PROJECT: EU303 SIMONSHAVEN 380 kV SUBSTATION (SMH380) EXPANSION (DP2-4)

ITEM: Task 2 – Comments on Photos from Nulinspectie

Prepared by: Pieter H Pretorius

Date: 22 Jan 2026

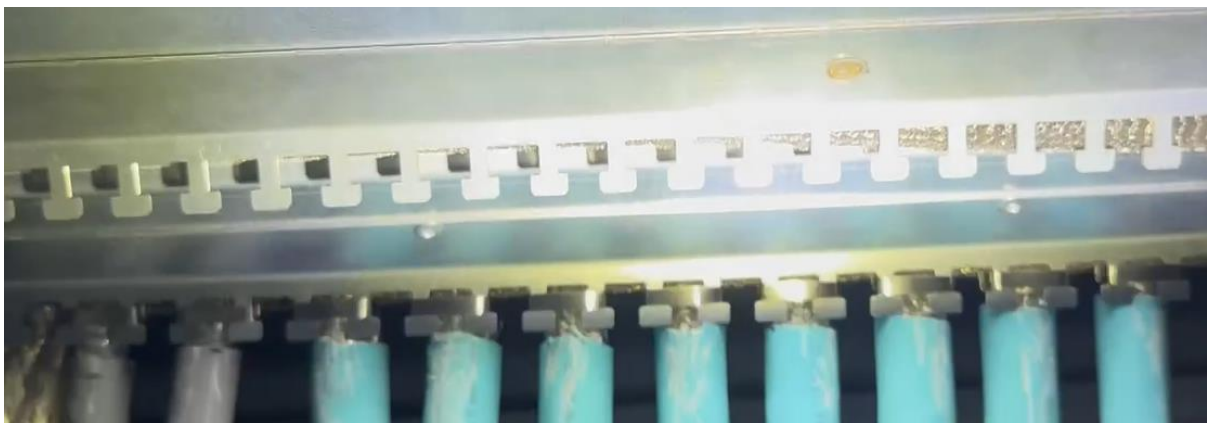
1. IMG_6466 (1 to 4 – Possible cables with shields passing through base plate without shields being bonded to base plate or via EMC glands).

2. IMG_6466 ((1) – Excess cable coiled – coiled cable with shield exposed to magnetic fields and passing through base plate without shield being bonded to plate or via EMC gland (2)).

3. IMG_6466 (Good example of cable shields being bonded to base plate).

4. IMG_6467 (Good example of cable shields being bonded to base plate).

5. IMG_6469 (1 – Possible cables with shields passing through base plate without shields being bonded to base plate via EMC glands).

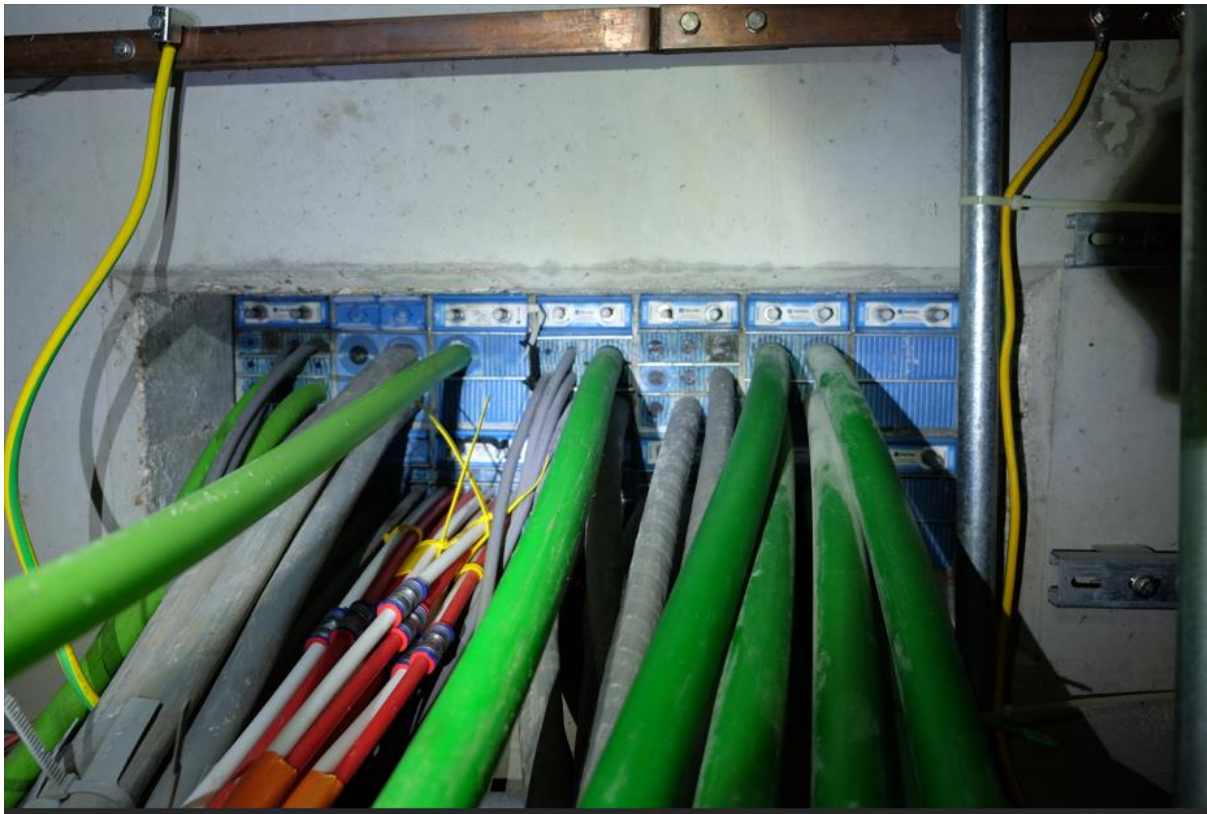
6. SMH002 (Is Roxtec metal frame bonded to earth – as discussed).

1. SMH045 (Example of corrosion – most likely caused by dissimilar metals).

2. SMH051 (Appears to be plastic connectors that are not EMC compliant).

3. SMH056 (Poor electrical contact (lugs on paint and not metal)).

1. IMG_6491 (Appears to be plastic connectors that are not EMC compliant).

4. IMG_6492 (Good example of use of EMC connectors – bonding of cable shields to enclosure to be confirmed by measurement).

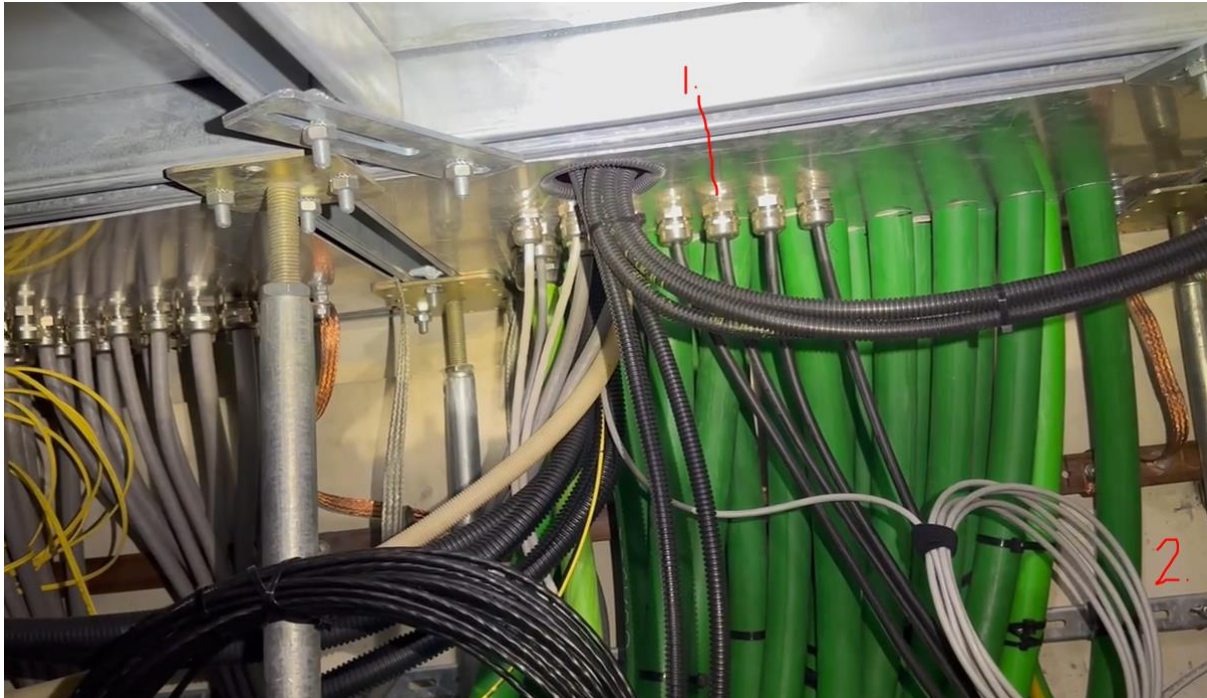
1. IMG_6470 ((1) – Possible cables with shields passing through base plate without shields being bonded to base plate or via EMC glands). (2) – Excess cable coiled – coiled cable with shield exposed to magnetic fields and passing through base plate without shield being bonded to plate or via EMC gland).

2. SMH042 (Appears to be plastic connectors that are not EMC compliant).

1. SMH064 ((1) and (2) appears to be plastic connectors that are not EMC compliant).
